TRUCK MEDIUM MC2 (MERCEDES BENZ) - ALL TYPES
CLUTCH MASTER CYLINDER REMOVAL

MODIFICATION INSTRUCTION

FIG 1 - DIMENSIONS FOR DRILLING OF 25MM DIAMETER HOLE

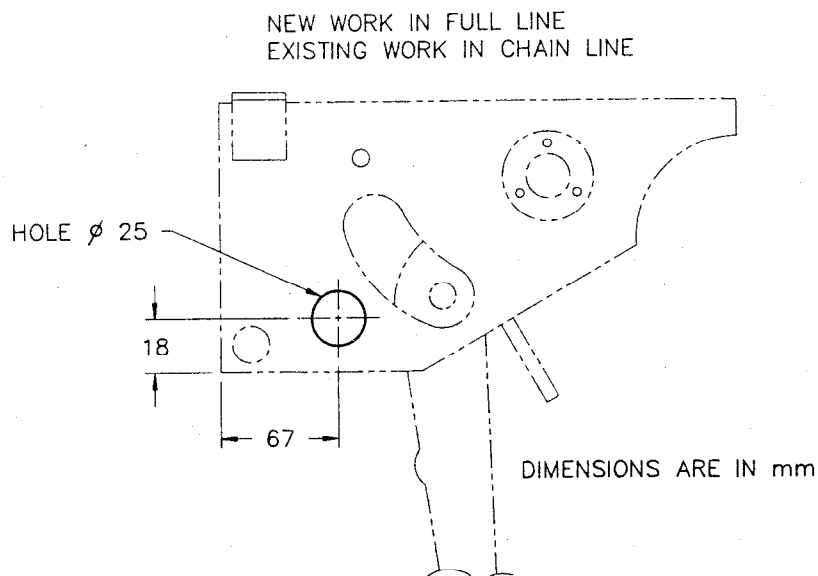
6. Carry out the modification as follows:
 - a. Remove the clutch master cylinder and bracket assembly as detailed in VEH G 603.
 - b. Remove the service brake valve assembly and mounting bracket as detailed in VEH G 603.
 - c. Drill a 25mm diameter hole in the brake mounting bracket as shown in Fig 1.
 - d. Refit the service brake valve assembly and mounting bracket as detailed in VEH G 603.
 - e. Refit the clutch master cylinder and bracket assembly as detailed in VEH G 603.
